**CHARTER TOWNSHIP OF GARFIELD
PLANNING COMMISSION MEETING**

Charter Township of Garfield Planning Department Report No. 2025-2			
Prepared:	January 2, 2025	Pages:	8
Meeting:	January 8, 2025 Planning Commission	Attachments:	<input checked="" type="checkbox"/>
Subject:	TowerNorth Wireless Communication Facility Special Use Permit – Public Hearing		
File No.	SUP-2024-02	Parcel No.	05-019-001-00 (part)
Applicant:	TowerNorth Development, LLC		
Agent:	Jaime Mathew w/Kimley-Horn and Associates, Inc.		
Owner:	Frank A Bare

SITE PLAN
DETAIL

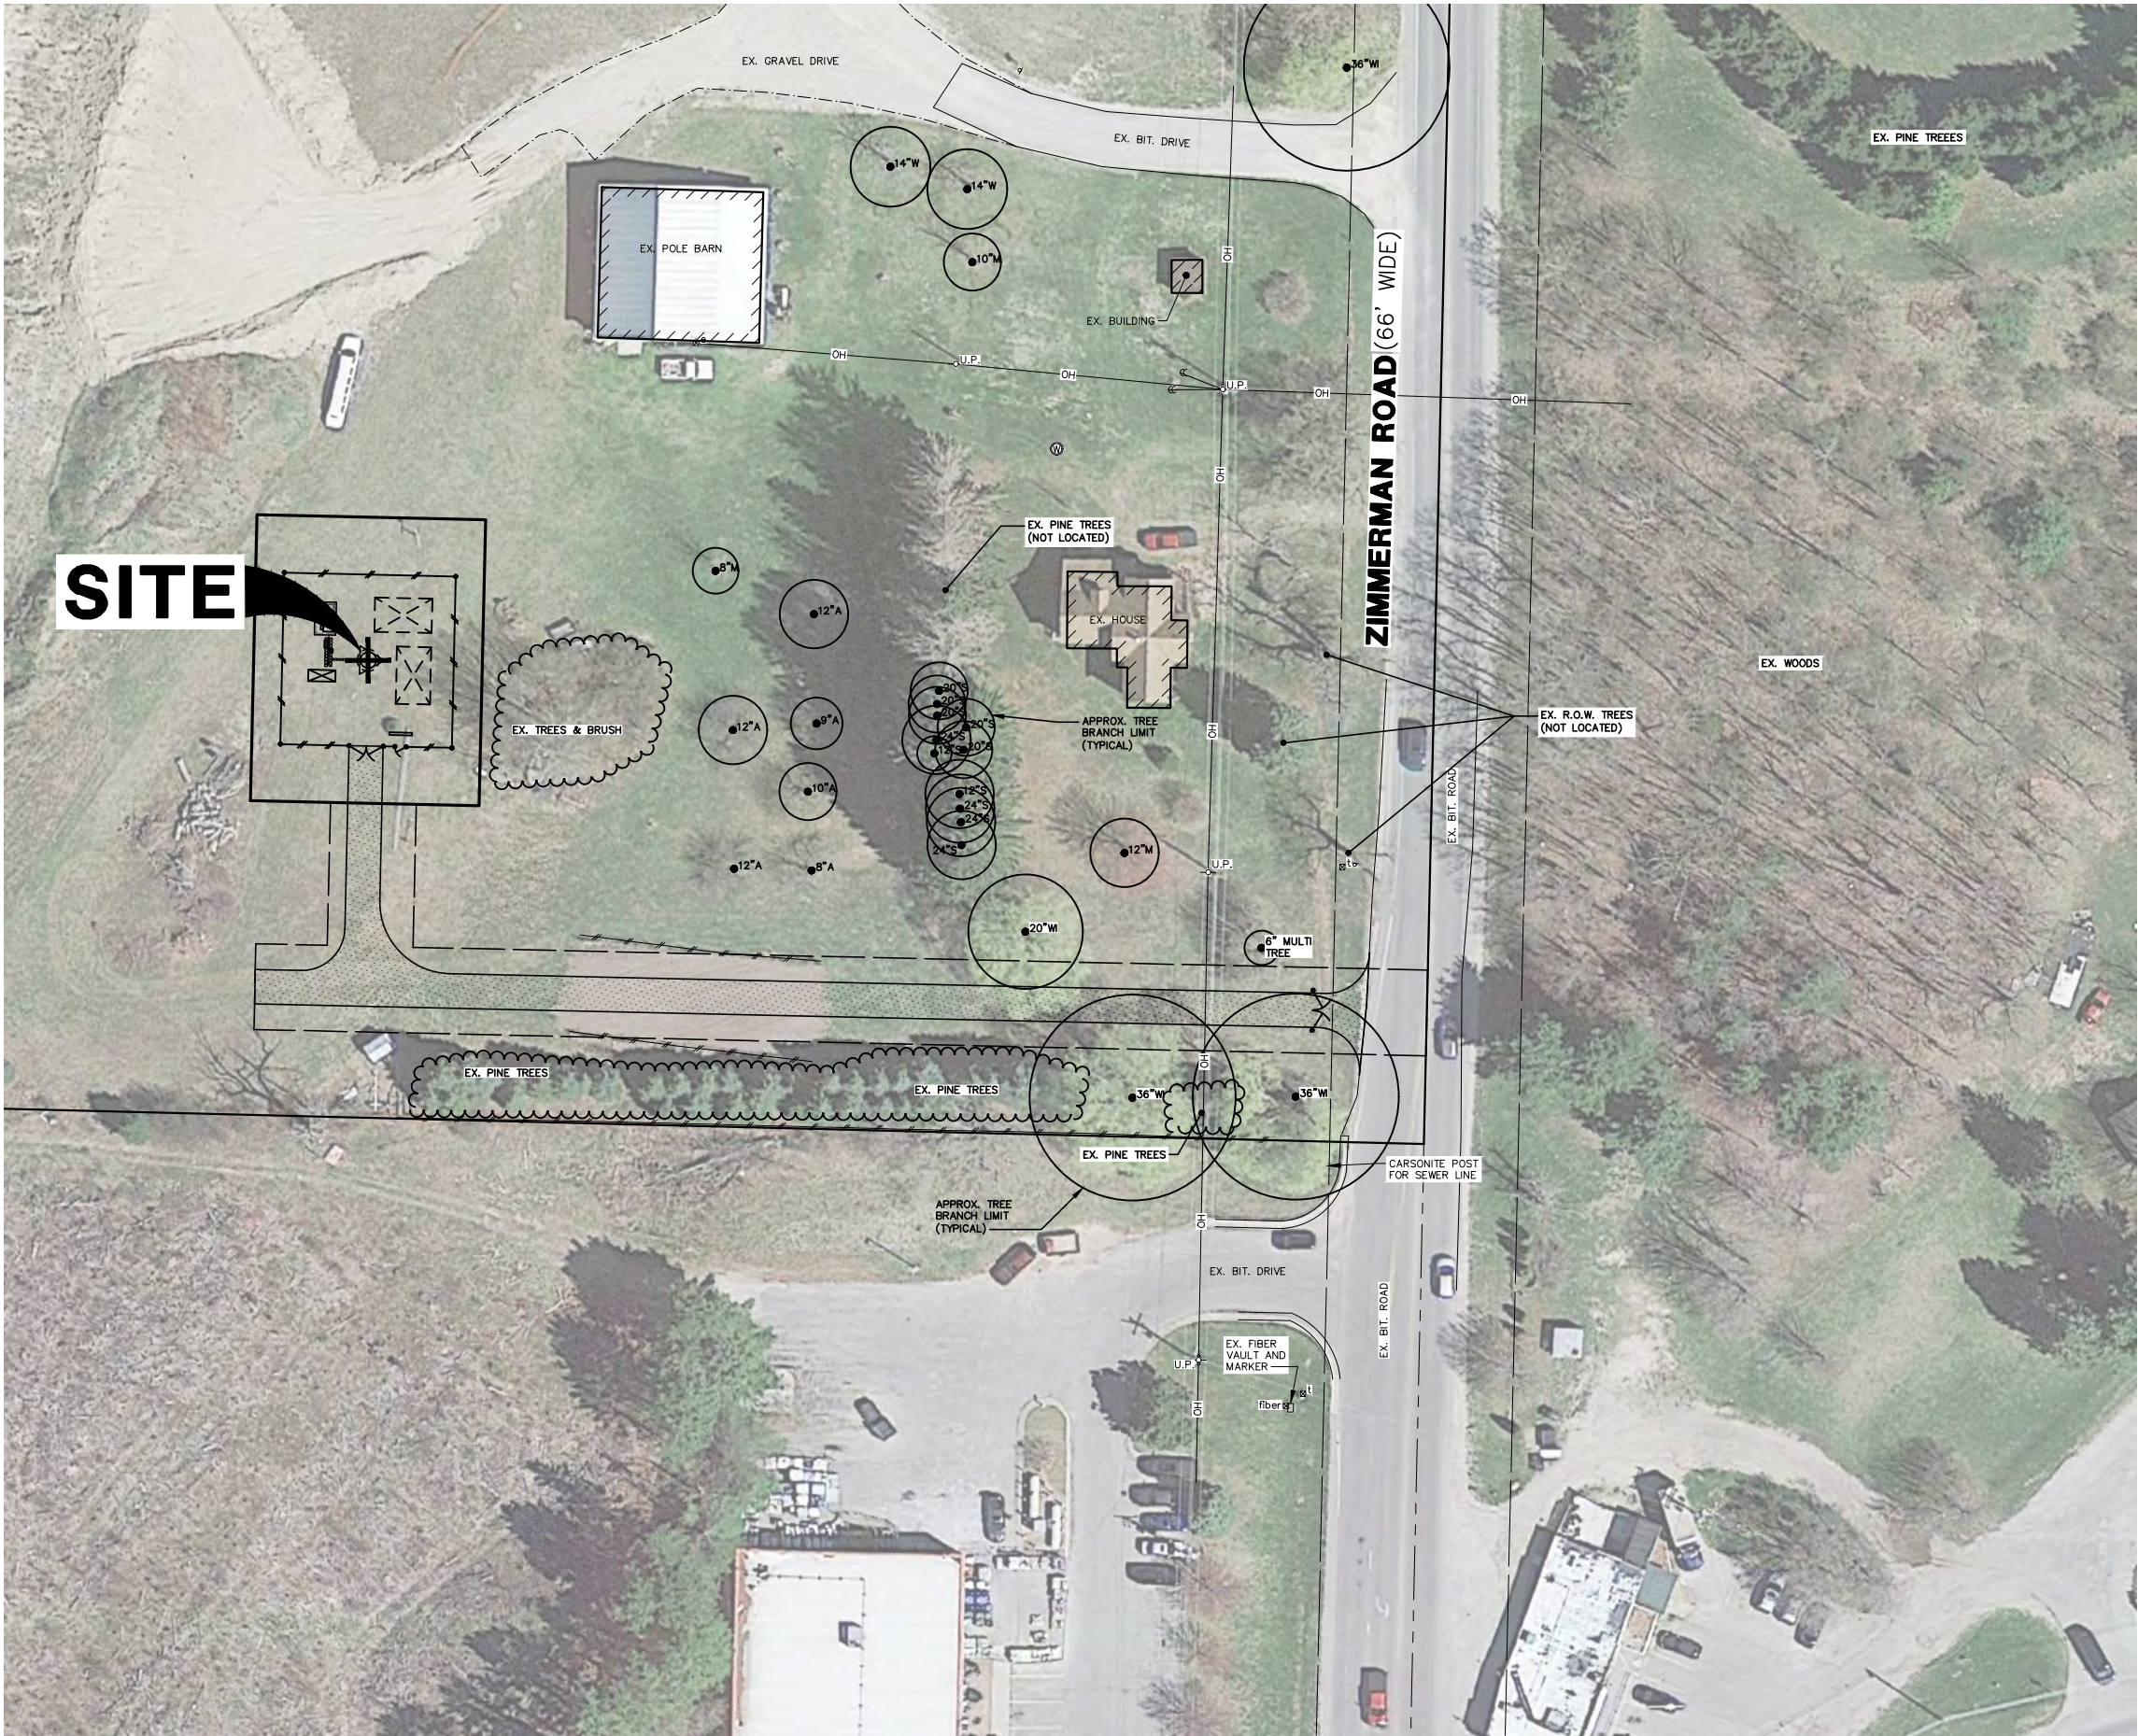
The cover letter notes the ground equipment will be less than 15 feet in height. The updated site plans need to show an elevation sketch of the ground equipment and shelter.

The updated site plan shows a 60' x 60' fenced-in area with a 6'-high chain link fence and indicates that there will be a 12-foot-wide double leaf gate and a 4-foot-wide swing gate for the fenced area. There is also a proposed entrance gate for the drive leading up to the leased area, details of which are shown on the site plan.

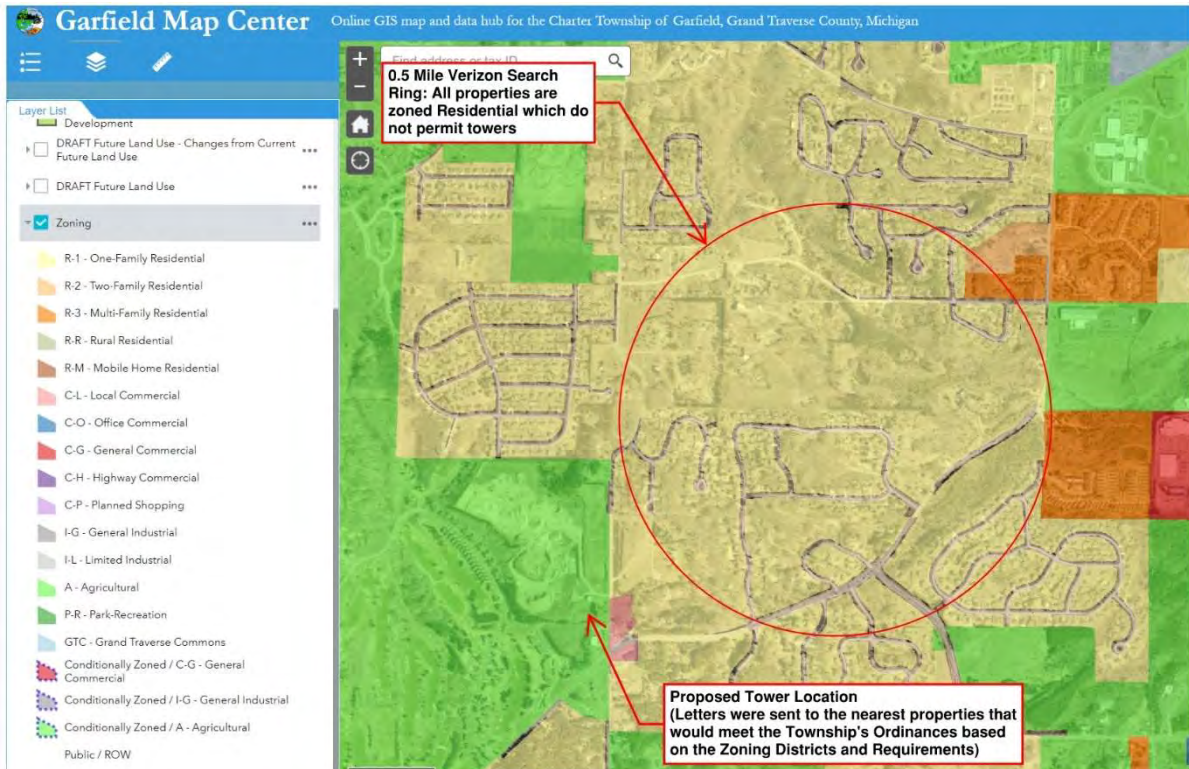
1. The Planning Commission requested renderings (photo simulations) of the proposed tower along Zimmerman Road to visualize the tower location and the existing landscaping/screening.

Response: Please see the attached existing vs. proposed photo simulations of the proposed tower from four (4) different vantage points along Zimmerman Road. The renderings show the natural screening of the tower provided by the existing landscaping along Zimmerman Road and the South property line. There are no plans to remove the existing large spruce trees for the construction of the wireless communication facility.

- From a construction standpoint, the water tower is not designed to structurally support a 50ft+ steel extension and would require extensive modifications and reinforcements. This would require the existing carrier to remove their equipment on the tower and construct a temporary structure to limit the loss in coverage. Depending on the lease agreement with the existing carrier, they likely also have the first right of refusal any may deny Verizon's request for removing/relocating their equipment in order to construct the extension.
- The existing water tower is also located in a residential community surrounded by houses (and a few recently constructed new homes), so the addition of a 50ft-87ft extension for the antenna equipment would likely not be welcomed by the existing property owners.

SNOW STORAGE CALCULATIONS:
10 SFT/100 SFT PARKING AREA
EXISTING PARKING AREA = 17,706 SFT
PROPOSED PARKING AREA = 9,683 SFT
TOTAL PARKING AREA = 27,389 SFT
REQUIRED SNOW STORAGE AREA: 2,739 SFT
PROVIDED SNOW STORAGE AREA = 5,583 SFT

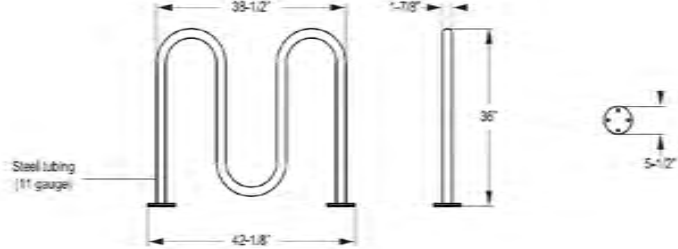
Snow storage is required at a ratio of ten (10) square feet per one hundred (100) square feet of parking area. The updated Sheet C-1 provided for the December 11, 2024 meeting includes snow storage calculations showing a required snow storage area of 2,739 ft² and total snow storage area of 5,583 ft² provided. The updated site plan added an 1,892-square-foot snow storage area next to the westernmost parking spaces with the rest of the snow storage area next to the proposed building addition in the retention basin as shown previously. The Township Engineer may review if the retention basin can be used as part of snow storage.

BIKE RACK DETAIL

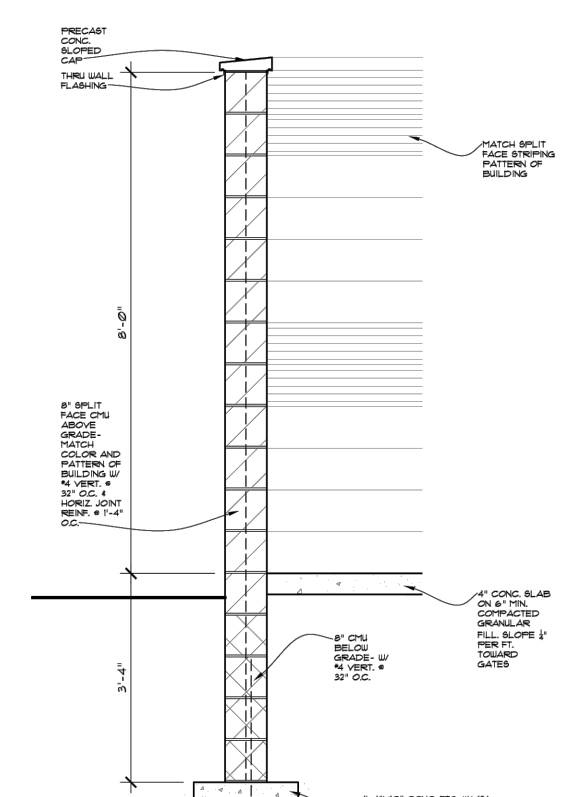
Bicycle parking shall be provided at the rate of 2 bicycle spaces per 25 motor vehicle spaces. Based on this standard, 4 bicycle parking spaces are required. A proposed bike rack is shown at the southeast corner of the existing building; details of this bike rack are shown on Sheet C-1.

4 DUMPSTER ENCLOSURE SECTION

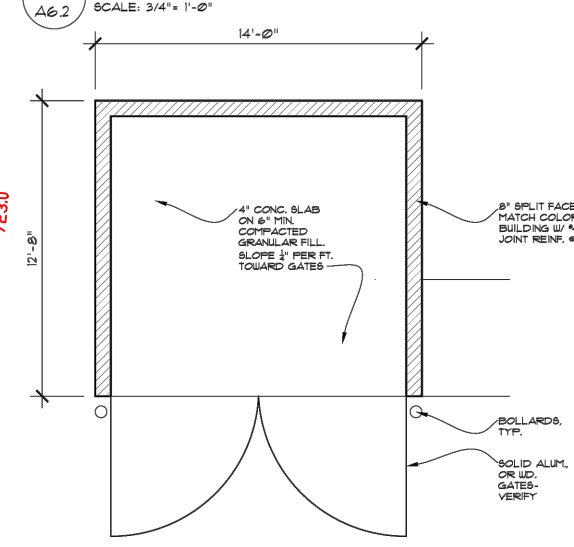
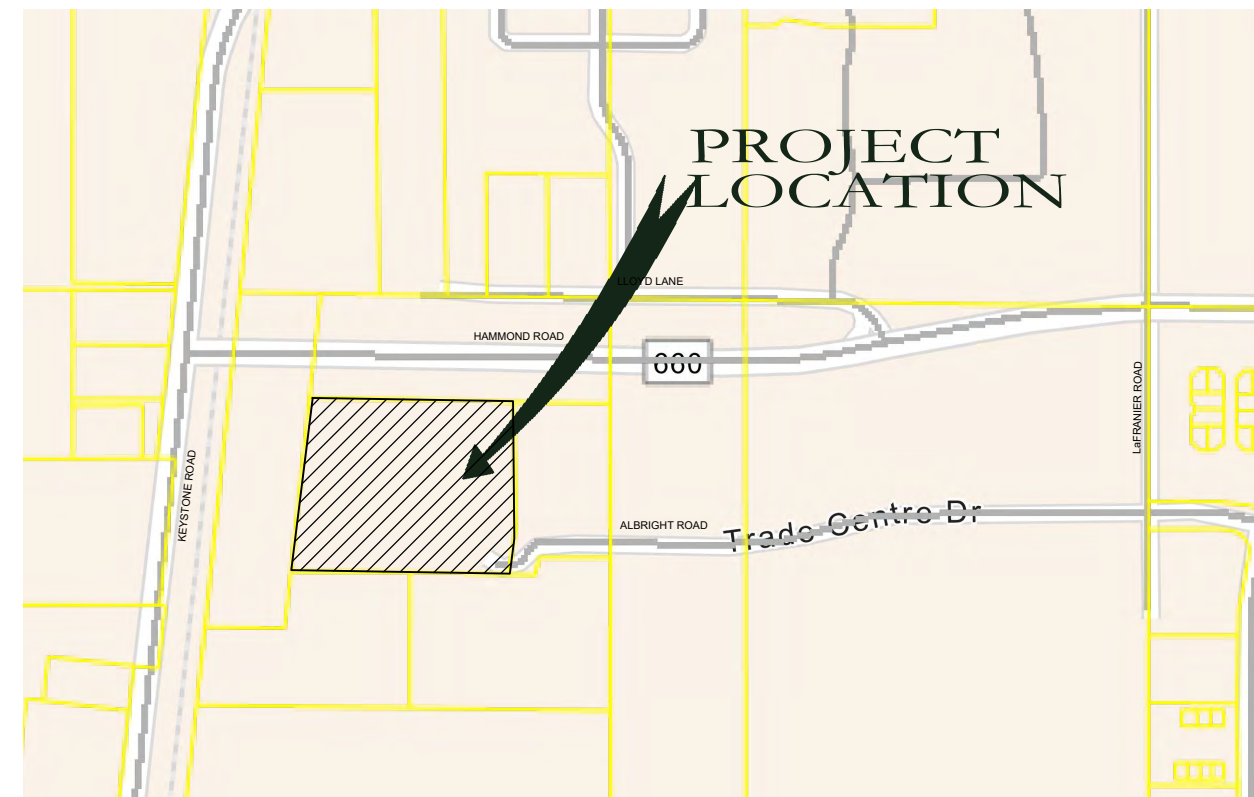
Dumpster enclosures are subject to Section 516 of the Zoning Ordinance. The site has an existing dumpster enclosure at the edge of the property which is proposed to remain. The site plan also indicates a proposed “screen dumper” at the southwest corner of the proposed building addition. Details for this enclosure are on the updated Sheet C-1. The enclosure will be 8’ tall, 12’ 8” deep, and 14’ wide. The sides are proposed to be 8” split face CMU and match the color and pattern of the building. The gates are proposed to be either solid wood or aluminum.
